Technical Service Bulletin: TSB180058

Released Date: 29-Apr-2019

Belt Noise and Front Engine Accessory Drive Belt Re-routing: Tiffin Recreational Vehicles

Figure 3, existing Design (Tiffin RV). Compressor Belt Has Already Been Removed From This Figure.

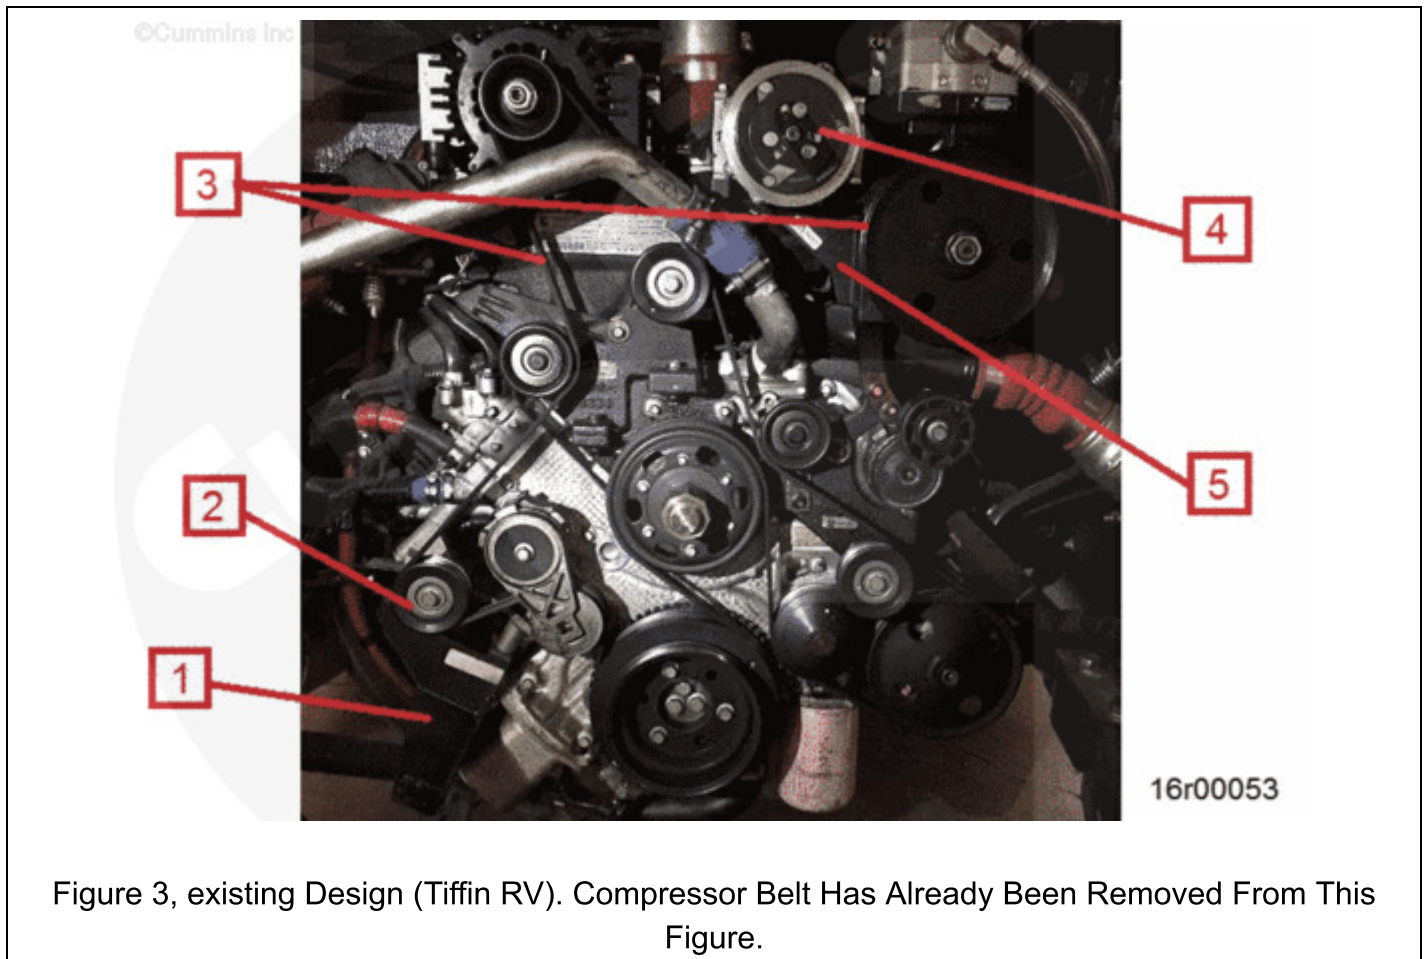
- Belt noise/squeal or belt damage on the secondary belt plane which wraps around the air compressor and the high mount refrigerant compressor.

- Insufficient belt wrap around the air compressor pulley.

1. Refrigerant compressor wiring connector.
 2. Refrigerant compressor supply and return lines.
4. Remove and discard belts, Part Number: 4335361 and 4335602 (Figure 3).
 5. Remove and discard lower idler pulley assembly, Part Number 4390735 (Figure 3).
 6. Remove refrigerant compressor (Figure 3) from upper refrigerant compressor support.
 - a. Mounted on refrigerant compressor support bracket, Part Number 4360003 (Figure 3).
 - b. Two Sanden refrigerant compressor models have been identified as being used in Tiffin production.
 - i. Model number U4520 - Reuse compressor.
 - Move from high mount location to low mount location.
 - ii. Model number U4897 - Replace compressor with U4520
 - Use in low mount location

- Move refrigerant compressor from high mount to low mount. See Service Instructions section below.
- Install new Tiffin fan shroud mounting brackets.

- Change belt options to CP80008 and WP80038 for increased belt wrap on second belt plane around the air compressor.

Figure 4, Lower Accessory Drive Mounting with L-Bracket and P-Clamp.

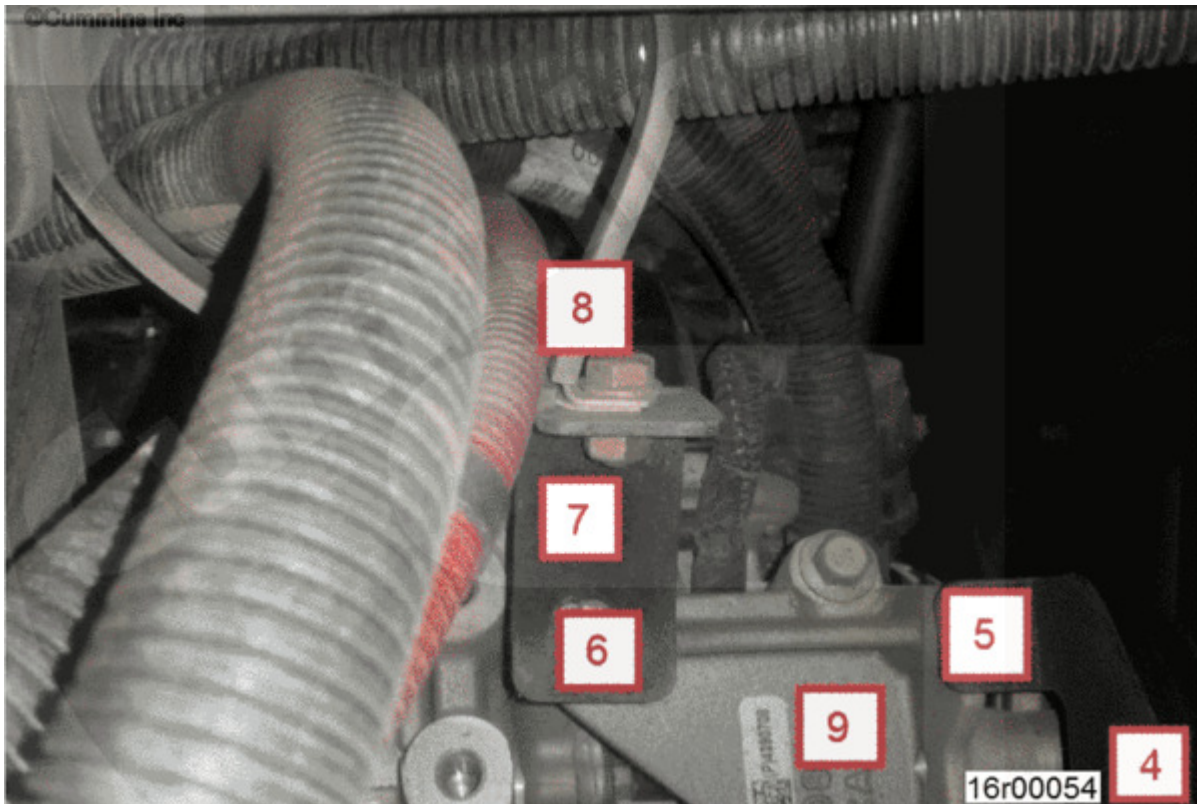
1. OEM Lower Fan Shroud Support Bracket.
 2. Lower Idler Pulley.
 3. Belts to be removed.
 4. Refrigerant compressor.
 5. Upper refrigerant compressor Support.
7. Remove L-Bracket (Figure 4 - 7) and P-clamp (Figure 4 - 8) assembly from lower accessory support, Part Number 4390708 (Figure 4 - 9).
 - Disconnecting P-clamp from bracket is **not** necessary.
 8. Remove OEM lower fan shroud support bracket (Figure 4 – 4) mounted to lower accessory support bracket, Part Number 4390708, (Figure 4 - 9) and OEM fan shroud.
 - a. Reuse p-clip mounting bracket (Figure 4 - 7), capscrews, washers, and nut at fan shroud position. (Figure 4) Tighten all fasteners to proper specifications.

9. Install Sanden refrigerant compressor on lower accessory support, Part Number 4390708 (Figure 4 - 9).

- a. Do **not** tighten capscrews at this time.
- b. Reuse two of the OEM supplied refrigerant compressor mounting bolts from upper mount configuration. (capscrews M8 x 80mm x 1.25)
- c. Install first capscrew in the lower mounting hole towards the rear of the engine.
- d. Install second capscrew (Figure 4 - 6) through the L-bracket and P-clamp assembly (Figure 4 - 8) in upper mounting hole towards the rear of the engine.

Note : Note: P-clamp may be on the inner side of frame rail in existing configuration, but P-clamp will move to the outer side of frame rail when repositioned.

Figure 7, OEM as built wiring harness routing to refrigerant compressor.

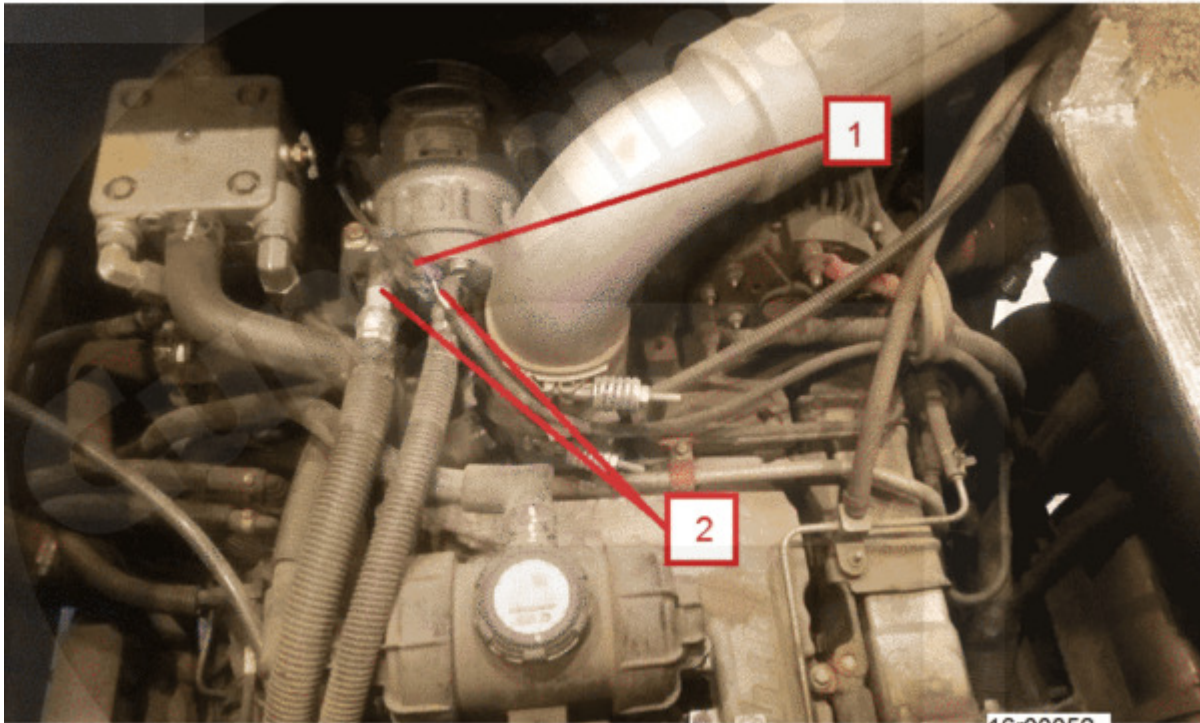
- a. Disconnect wiring connector at refrigerant compressor. Figure 7
- b. Remove wire from p-clamp secured to alternator. Figure 8
- c. Route wiring harness down to new refrigerant compressor location and connect to refrigerant compressor clutch connector.
- d. Secure wiring harness with plastic ties away from heat sources. Bundle any extra length of harness.

Figure 9, New Refrigerant Hose Mounting.

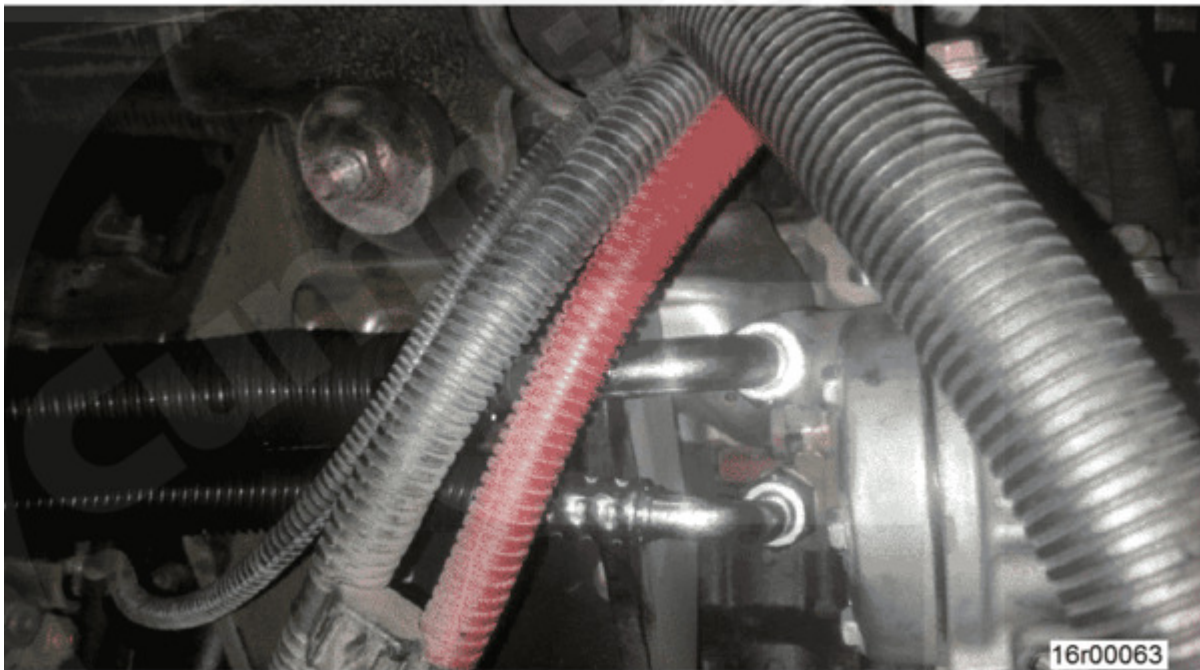
17. Route hoses to new low mount refrigerant compressor location. See Figures 8, 9, 10, and 11.

1. Use OEM Hose kit, Part Number 5083043, to attach existing hoses to new refrigerant compressor.
2. Low pressure return hose (smaller diameter of two hoses) **must** be extended.

- o Cut existing low pressure hose and crimp new connector onto existing low pressure hose.
 - o Do **not** stretch the existing low pressure hose.
3. Loosely connect the new low pressure hose extension to the refrigerant compressor.
